Moore'sCloud Holiday

Title		
Moore'sCloud Holiday - Aux CPU & I/O		
Size	Number	Revision
A4	*	3
Date:	14/02/2014	Sheet 2 of 2
File:	\\.\Holiday Aux r3.SchDoc	Drawn By: KJM

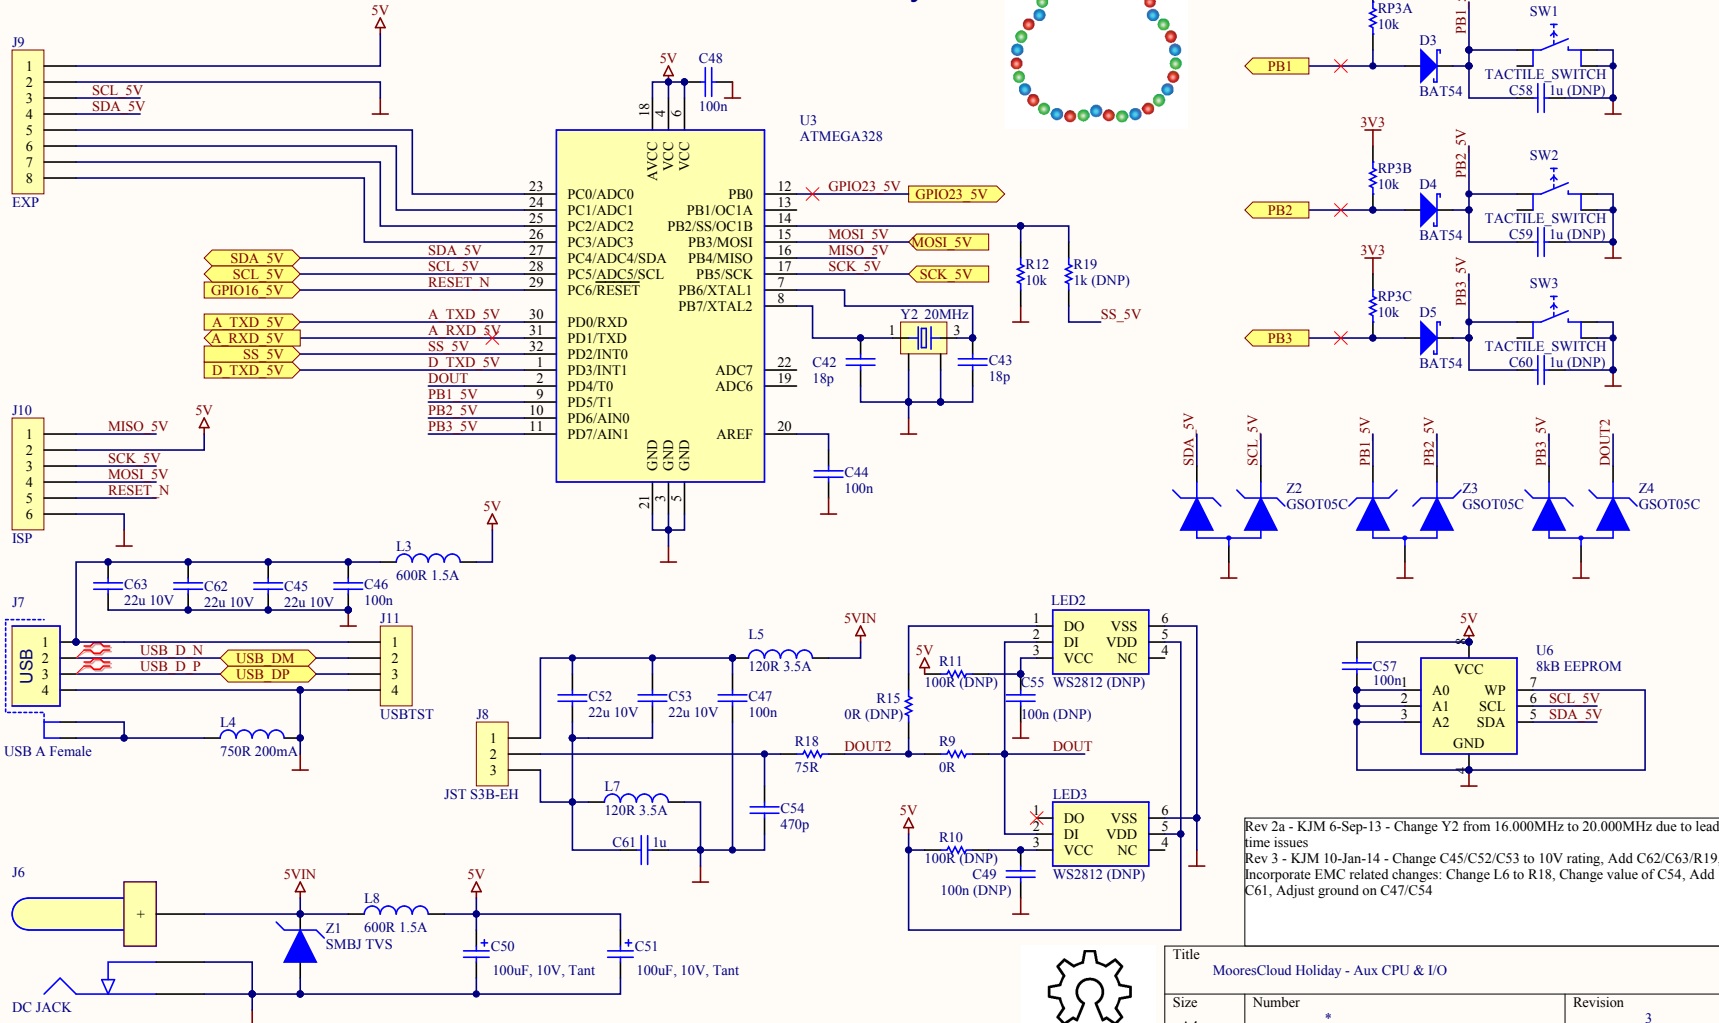
Rev 2a - KJM 6-Sep-13 - Change Y2 from 16.000MHz to 20.000MHz due to lead time issues
 Rev 3 - KJM 10-Jan-14 - Change C45/C52/C53 to 10V rating, Add C62/C63/R19, Incorporate EMC related changes: Change L6 to R18, Change value of C54, Add C61, Adjust ground on C47/C54
